REMARKS

This is intended as a full and complete response to the Office Action dated September 29, 2005, having a shortened statutory period for response set to expire on December 29, 2005. Please reconsider the claims pending in the application for reasons discussed below.

ATTY DKT. No.: APPM/007874/CPI/ALD/PJS
U.S. SERIAL No.: 10/644,598
FILED: AUGUST 20, 2003
APPLICANT: APPLIED MATERIALS, INC.
TITLE: ELECTRONICALLY ACTUATED VALVE
INVENTORS: NGUYEN, ET AL.

FIGURE 1

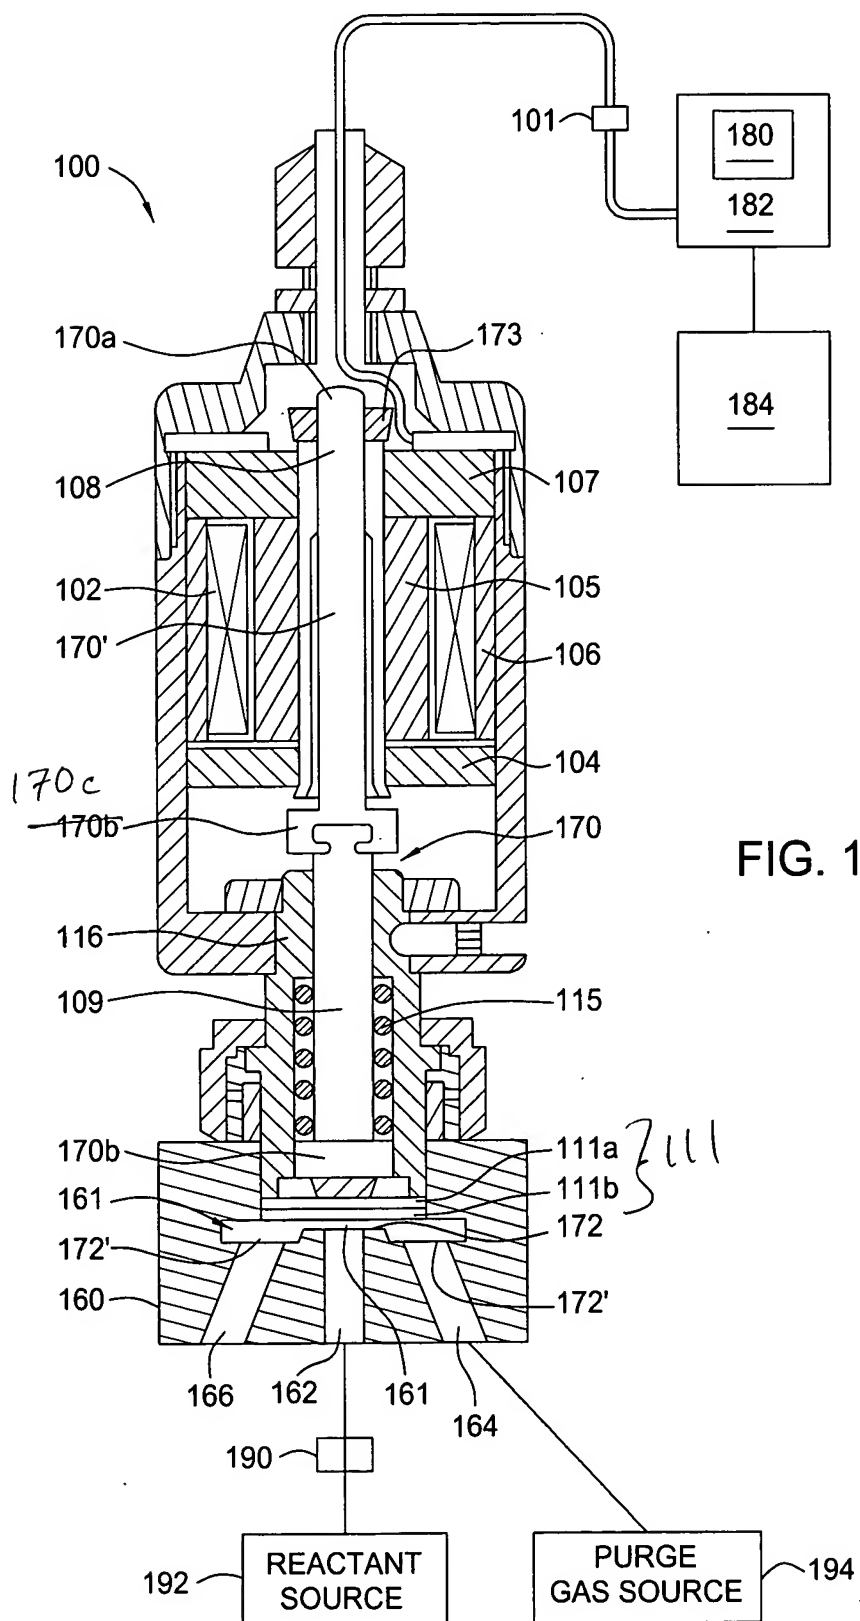
In amended Figure 1, the previously omitted element numeral 111 has been added. In Figures 1 and 2, one occurrence of reference numeral 170b has been amended to 170c. No new matter has been added.

Applicant acknowledges the objection to the drawings where the Examiner asserts that the solenoid coil [102] is not shown being attached to the piston [170']. Applicant respectfully traverses the objection and submits that the feature is shown in Figures 1 and 2, absent amendment. Applicant submits that Figures 1 and 2 are generic and one skilled in the art will realize that the solenoid coil [102] may be attached to magnet [107], which may be attached to the movable shaft [108]. Applicant respectfully requests that the objection to the drawings be withdrawn.

The attached sheet of drawings includes changes to Figs. 1 and 2. These sheets, which include Figs. 1-2, replaces the original sheets including Figs. 1-2. In Figure 1, previously omitted element 111 has been added and one occurrence of 170b has been changed to 170c, to coincide with the description of the Figure. In Fig. 2, as in Fig. 1, one occurrence of 170b has been amended to 170c. Applicant submits this was a clerical error and that no new matter has been added.
